Jillian Holford
Principal Planning Officer
Royal Borough of Greenwich
The Woolwich Centre
35 Wellington Street
London
SE18 6HQ

CHARLTON RIVERSIDE EIA: RESPONSE TO THE DRAFT FINAL REVIEW REPORT ON THE ENVIRONMENTAL STATEMENT – LAND USE CONSULTANTS, FEBRUARY 2018

Ref L1700001114_02

Table 1: Ramboll Responses to Clarifications, Planning Conditions and Potential Regulation 22s as raised by the LUC review of the ES

Summary of Scheme Changes

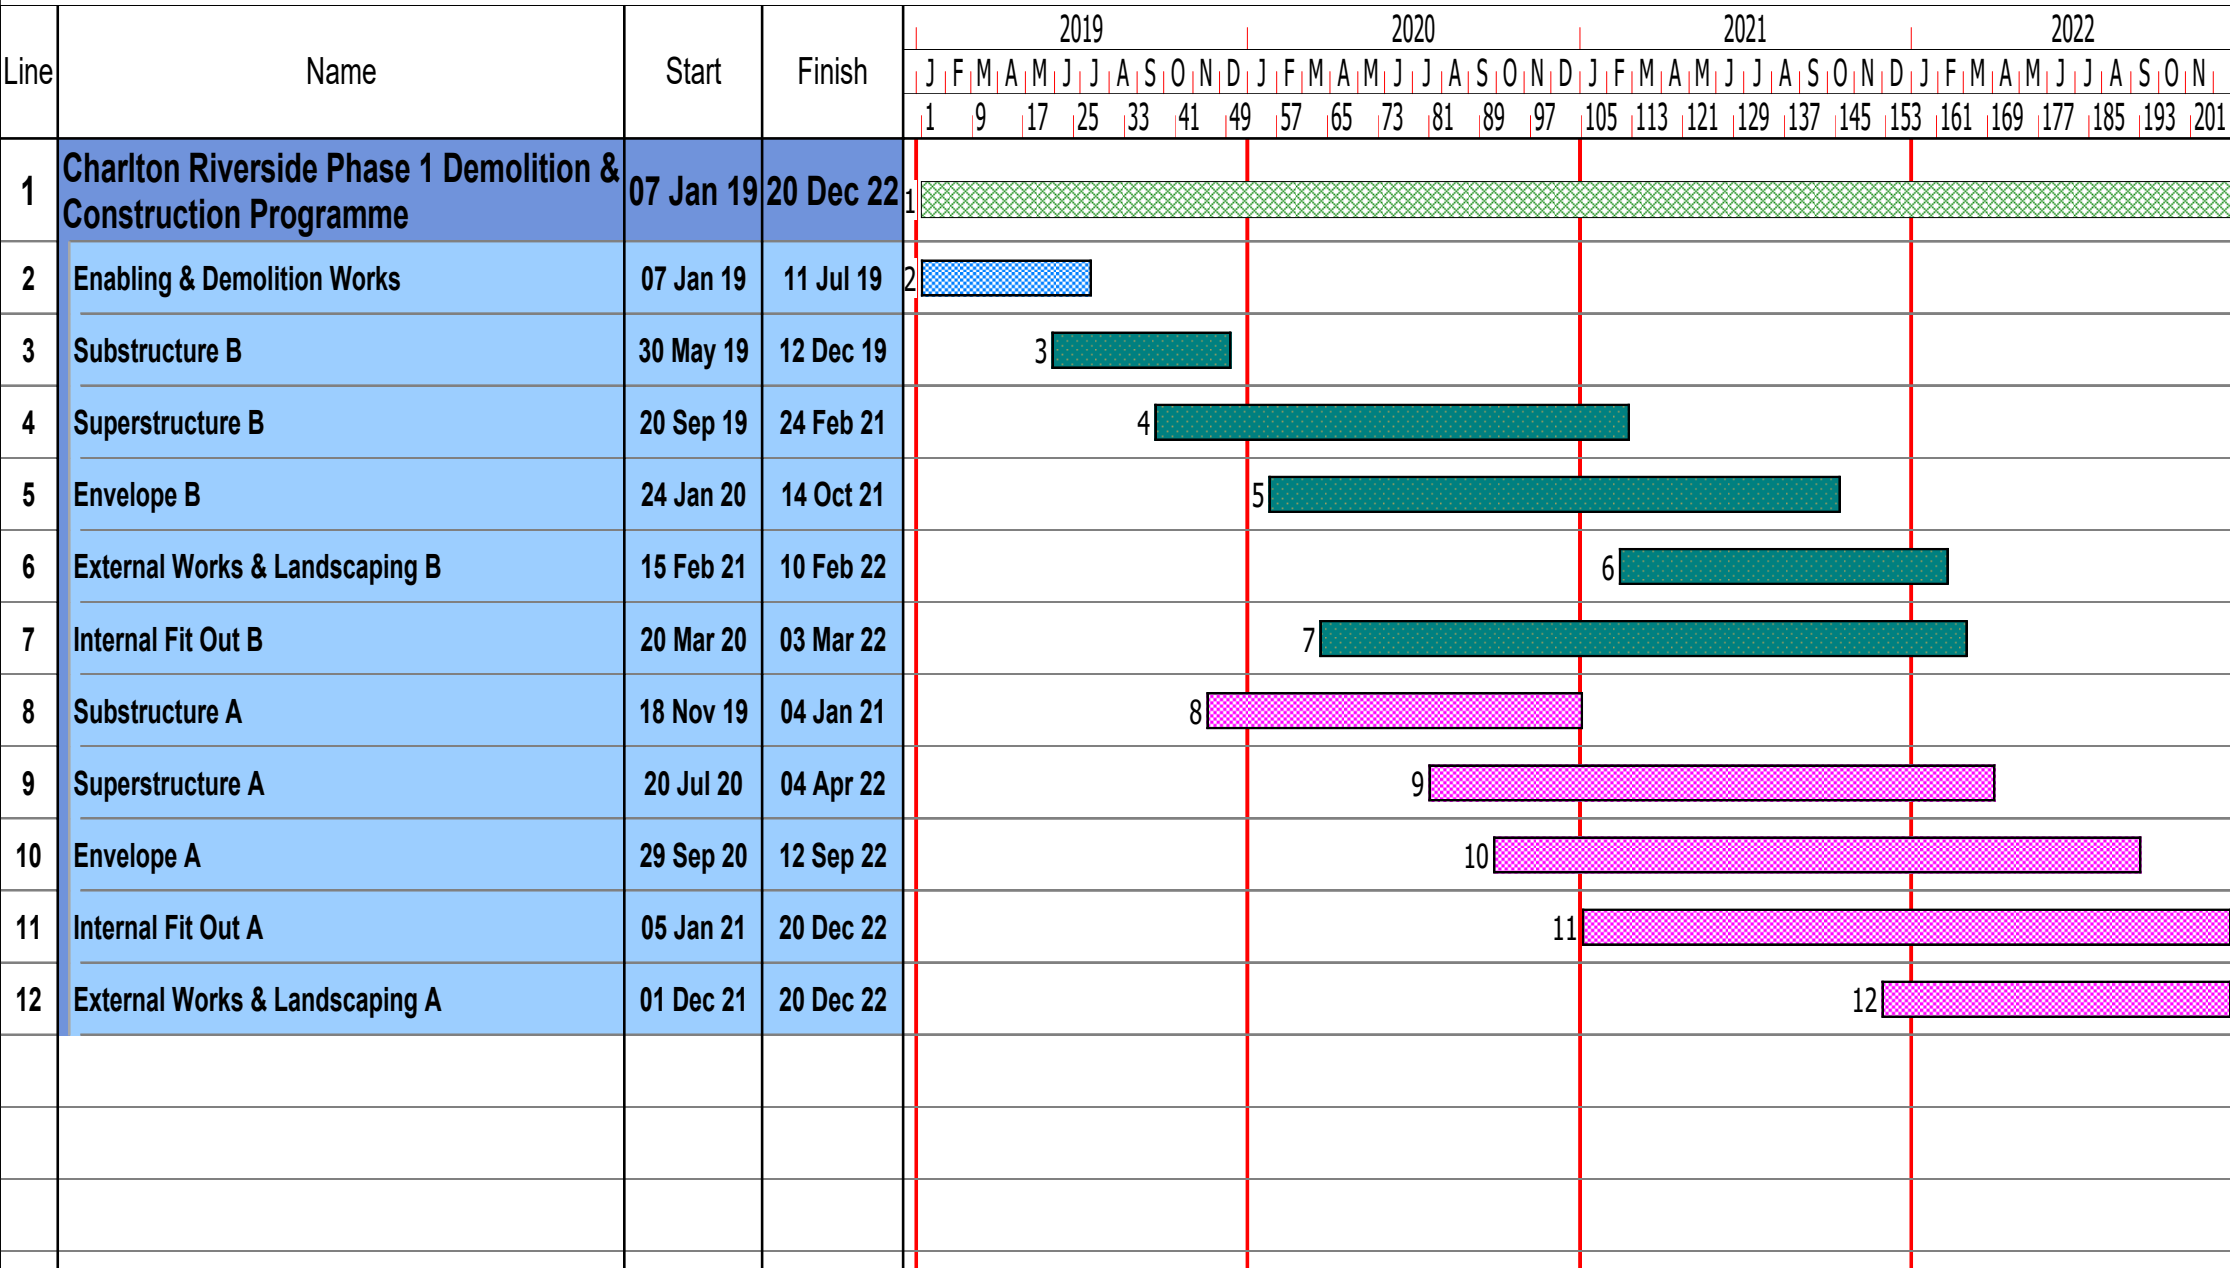
Type of Comment	LUC Comment on the ES	LUC Summary required from Applicant	Ramboll Response
Review of EIA Context and Influence (Chapters 2, 3 and 4)			
Clarification	For ease of reader understanding, it would be useful if the Applicant could provide a table which sets out the key differences between the 2016 scheme and the revised design, including in relation to building heights, floor space, number of properties, tenure etc.	Applicant to provide a summary table setting out the key differences between the 2016 scheme and the revised design, including in relation to building heights, floor space, number of properties, tenure etc.	In summary the key changes from the 2016 proposed development to the 2017 proposed development are outlined within Appendix A (Summary of Scheme Changes).
Clarification	In relation to the schemes included in the cumulative assessment, the Applicant has stated that a search of submitted schemes was carried out under established search criteria (located within 1km of the redline boundary and at least 10,000m ² (GEA) in floor area or would give rise to >150 residential units) and this did not identify any new schemes for consideration. Therefore, the cumulative assessments considered those schemes originally listed within the November 2016 ES. Where schemes previously identified have since been built and are completed, these form part of the baseline. It is understood from the review of the Townscape, Heritage and Visual Impact Assessment that this includes Brocklebank Industrial Estate (completed in August 2017); however, it is requested that the Applicant clarifies this as it is not clear from either ES Chapter 2: ES Process and Methodology or ES Chapter 13: Cumulative Effects.	Clarification to be provided on the schemes included in the cumulative assessment.	To confirm, Brocklebank Industrial Estate was treated as part of the baseline in the THVIA and not as a cumulative scheme as it has been built out.

Appendix A: Summary of Changes from the 2016 Scheme and 2017 Revised Scheme	
2016 Proposed Development	2017 Proposed Development
Residential Units	
975 units	771 units
Buildings	
9 buildings	11 buildings
Height from 2 to 28 storeys	Height from 2 to 10 storeys
Floor Areas (GIA)	
1,560 sqm of office space	3,236 sqm of flexible office, retail, community and leisure space
690 sqm of flexible retail/restaurant/café/leisure use	
407 sqm of community uses	833 sqm of flexible community, leisure uses and ancillary residential facilities
Ancillary residential facilities including gym, swimming pool, changing rooms totalling 864 sqm	
Miscellaneous	
Extensive external public realm improvements and landscaping	Extensive external public realm improvements and landscaping
Parking, services, plant and circulation	Associated car parking, cycle parking, plant and refuse areas

TVHIA – Built Heritage Assets Plan

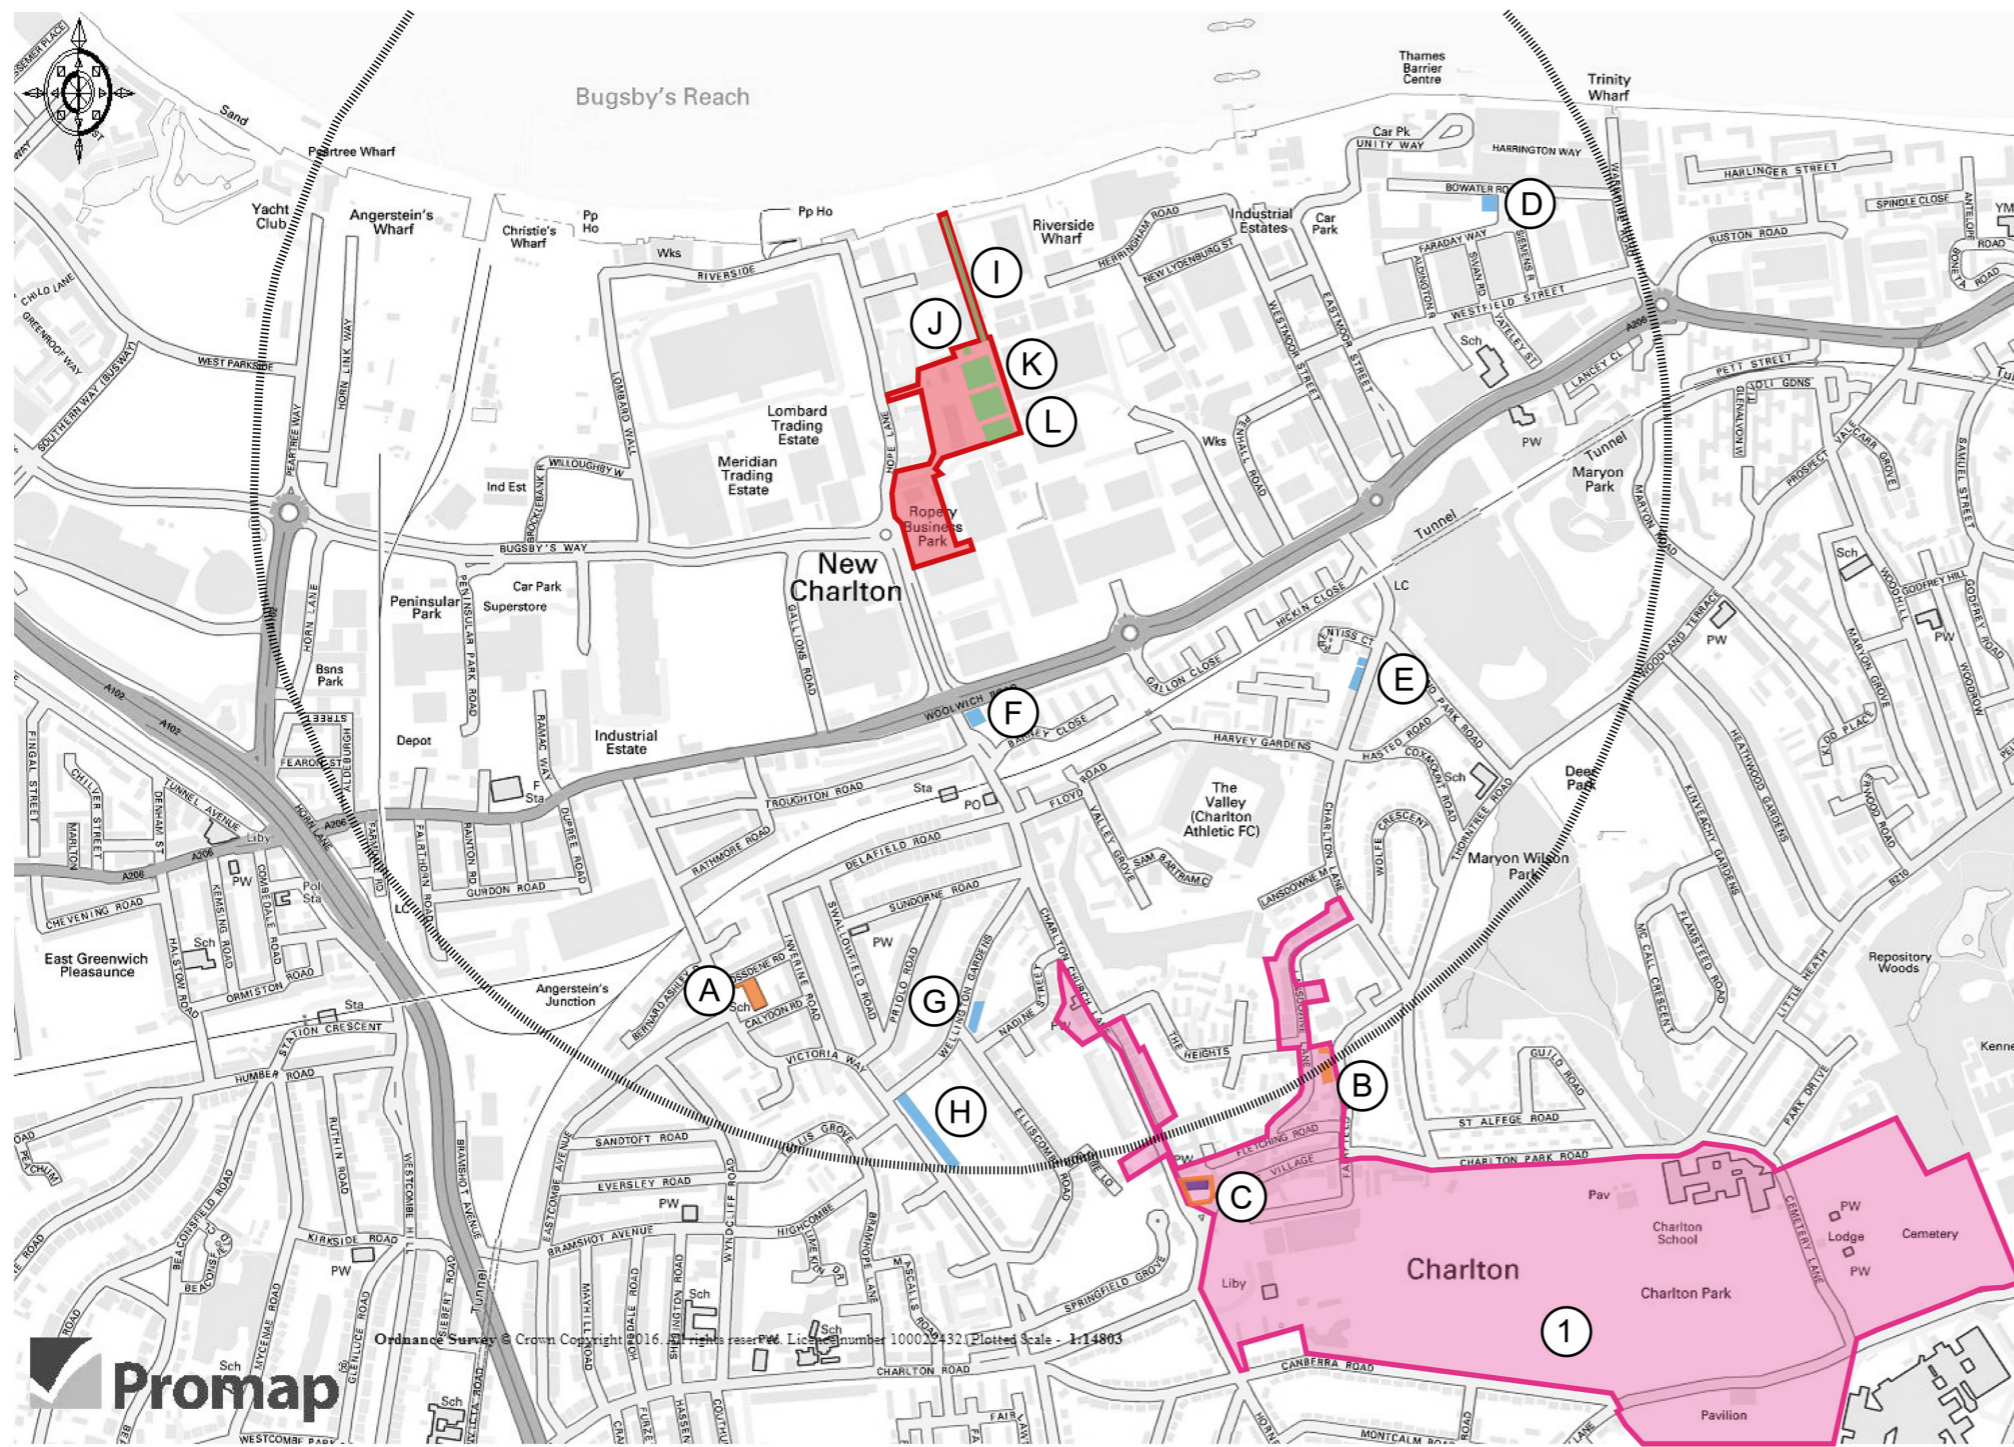
Type of Comment	LUC Comment on the ES	LUC Summary required from Applicant	Ramboll Response
Clarification	<p>The baseline discusses the significance of designated and locally listed heritage assets. It also includes a consideration of the CREHS-identified NDHAs which lie within the site and form part of the 'Charlton Ropeworks' complex. The NDHAs are shown on Figure 1 but are not labelled so it is not possible to identify which asset is which.</p> <p>It is requested that the Applicant add labels so that each NDHA discussed can be identified on the figure.</p> <p>The consideration of the heritage significance of the NDHAs appears to be limited to repeating text from the CREHS. This does not fully explain why these structures are thought to be heritage assets and what their significance is and is not comparable with the treatment given to other assets. As such, it is not clear how the ES conclusion of them as being assets of "very low sensitivity to change" has been reached. The Applicant appears to use, in part, the modified nature of the works and change of use of these structures to support ascribing a low sensitivity to change, going as far to state (4.40) that the piecemeal development of the ropeworks site means that it "is unrecognisable from visual inspection". This statement seems untenable since the consultants who prepared the CREHS were evidently able to perceive and identify several structures as deriving from the ropeworks during their site visits. The treatment of NDHAs appears cursory and fails to appreciate that they</p>	<p>The Applicant is requested to revisit how these assets have been described and assessed and add further information to explain their heritage significance.</p>	<p>These buildings and structures on the application site are considered in the TVHIA because of their identification as non-designated heritage assets (NDHAs) by others i.e. in the Charlton Riverside Employment and Heritage Study (CREHS) (albeit this is an evidence base document, and the identified buildings do not have any formal local recognition e.g. as locally listed buildings). We do not consider that they have sufficient heritage interest to be considered NDHAs, and would not have identified them as such. In these circumstances, it is considered reasonable and proportionate to rely primarily on the CREHS, as the document which has identified heritage significance, for explanation of what that heritage significance is. We consider it is nonetheless clear from the information provided in the TVIHA that whatever historic interest the buildings and structures have is attributed to their association with the former ropeworks on the application site, and the current state of the buildings and the degree to which that interest is legible is assessed.</p> <p>The level of detail provided is proportionate to the importance of the assets and sufficient to understand the potential impact of the proposed development on their heritage significance, in line with NPPF paragraph 128. Therefore, no further information is required to be provided.</p> <p>Appendix D comprises an updated map, illustrating the location of each NDHA discussed. Appropriate labels have been added.</p>
